Meeting: 5/15/2024
Project: Hill and Locust
Applicant: Ben Hudgins Brock Hudgins Architects

SUMMARY: Proposed new 18-story residential construction (10-13 stories of residential apartments above 5 stories of structured parking on the rear massing). The building is proposed for an L-shaped site at the intersections of W. Hill Ave., Locust Street, and Front Ave., located immediately north of Neyland Drive and the river. The site is significantly sloped towards the south and the river. The building is L-shaped, with a 6-story massing fronting W. Hill Ave and extending south along Locust Street, and the larger massing facing Front Ave.

APPLICATION FOR CERTIFICATE OF APPROPRIATENESS

0 W. Hill Ave.

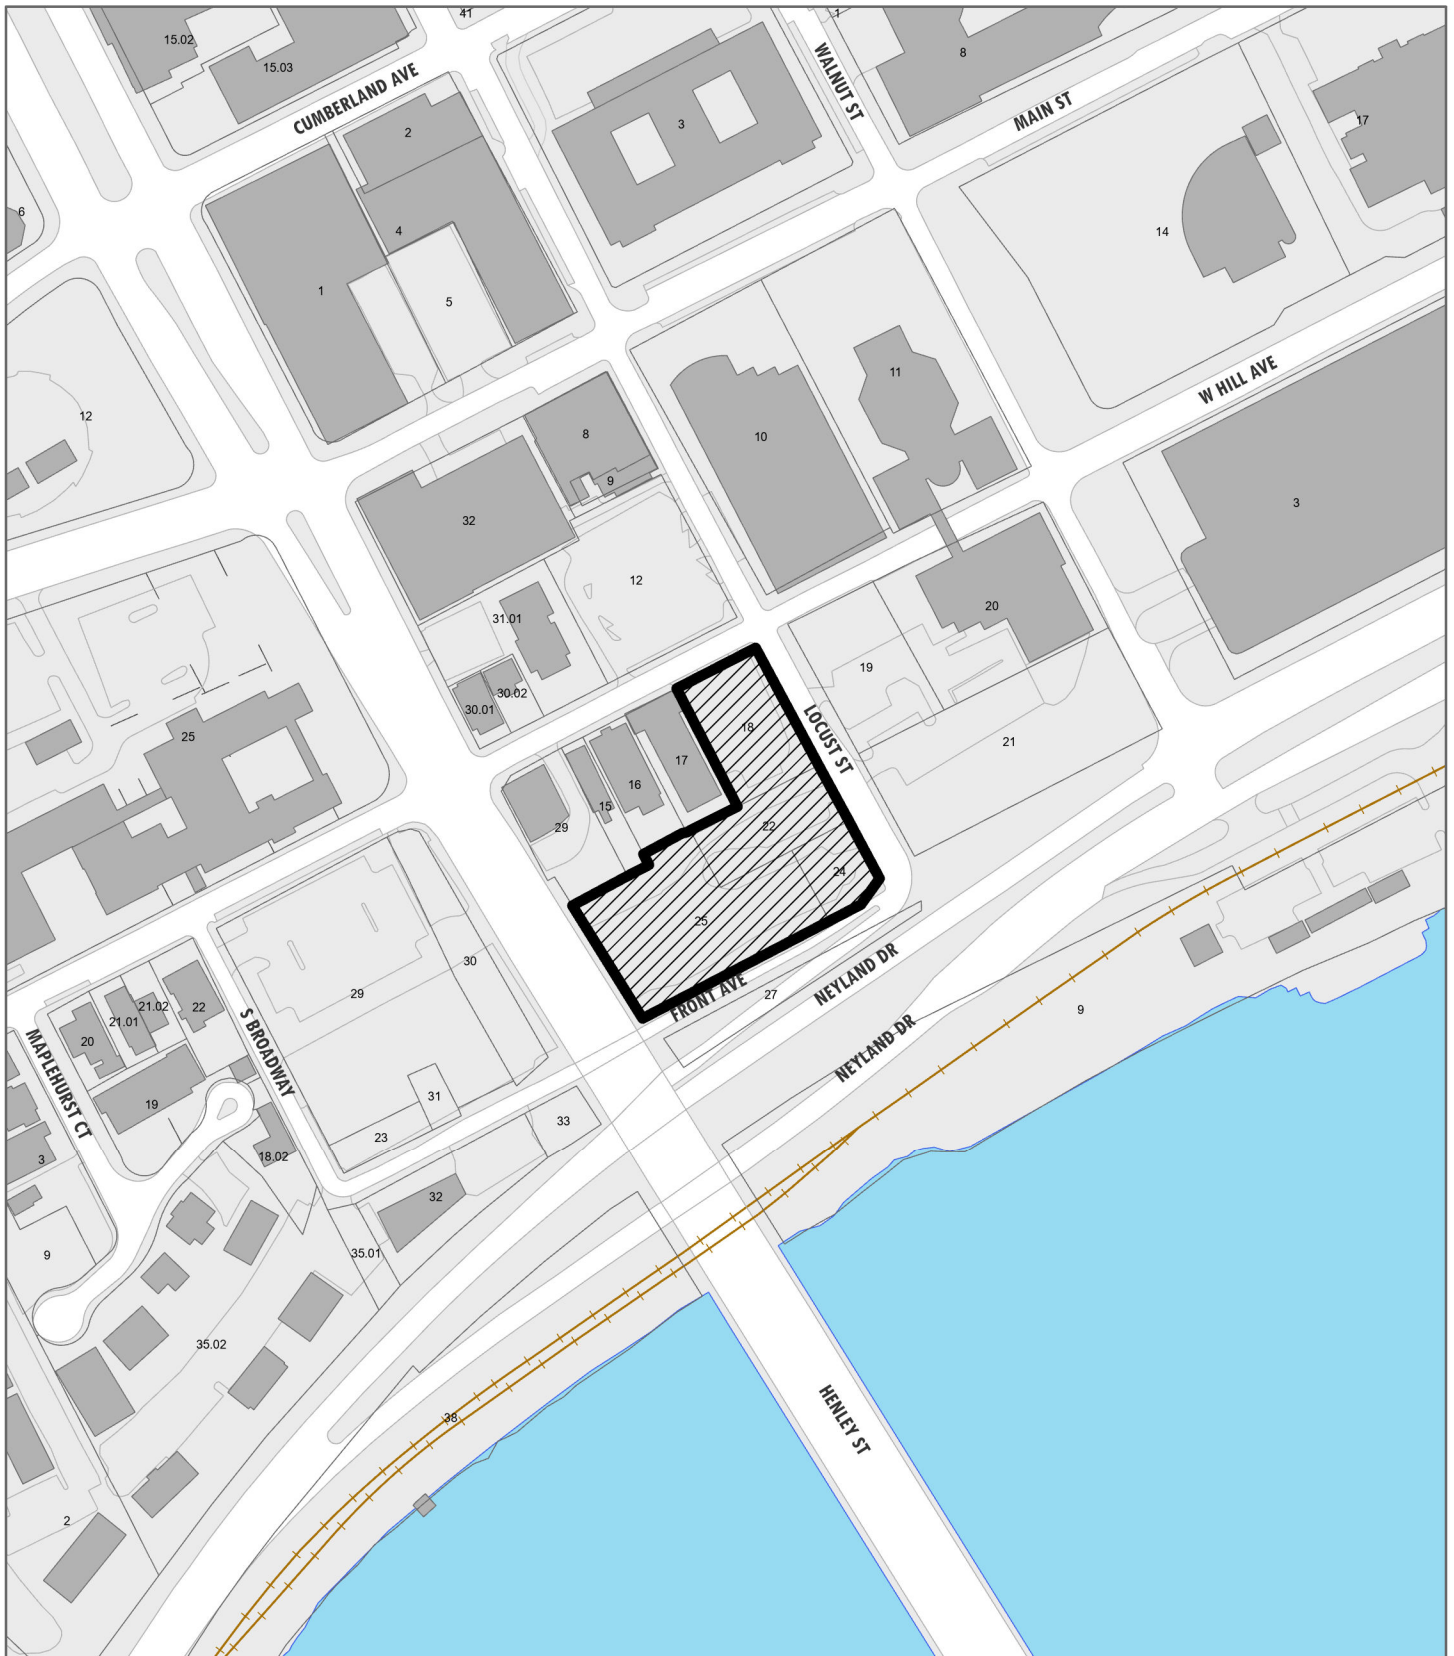
The parking garage design has been revised to include five-story tall diagonal supports. The new diagonal supports contribute to the visual prominence of the parking garage. The ground level of the parking garage is supported by cast-in-place concrete columns which are open to the exterior.
